Re: Docket Nos. SW-03575A-06-0545 and W-03576A-06-0545

Responses to Staff Insufficiency Letter

**Re: North and South West Service Area Extension
Water and Wastewater Services,
Docket SW-03575A-06-0545 and W-03576A-06-0545**

Reclaimed Water Expansion Exhibit

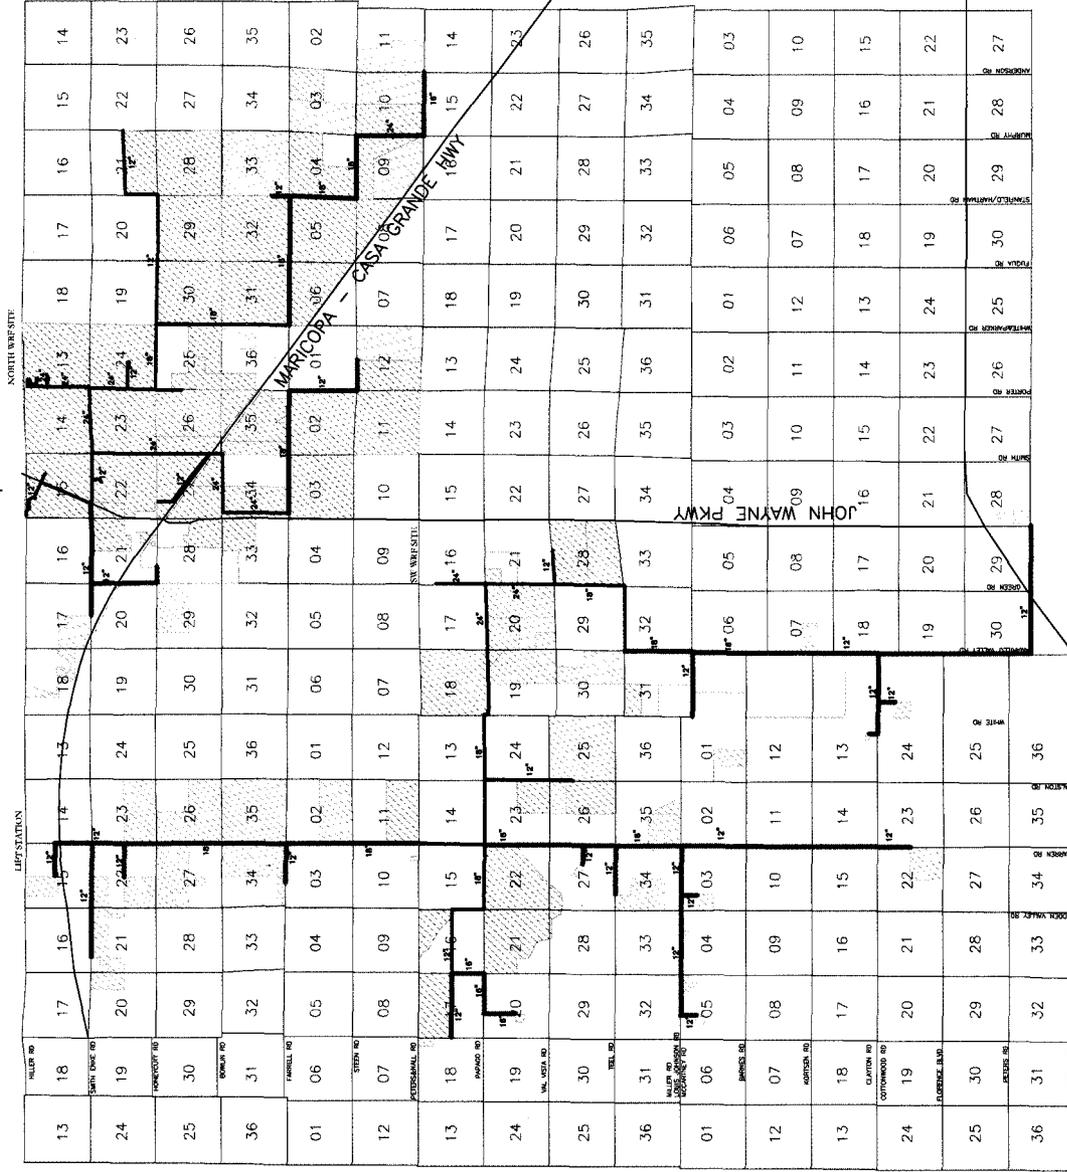
Question 4: The proposed wastewater plan and wastewater design report. This should include a reclaimed water disposal plan.

The reclaimed water master plan is shown in the attached exhibit. Pipe sizes and lengths are included in the attached table along with the cost opinion. Design documents are
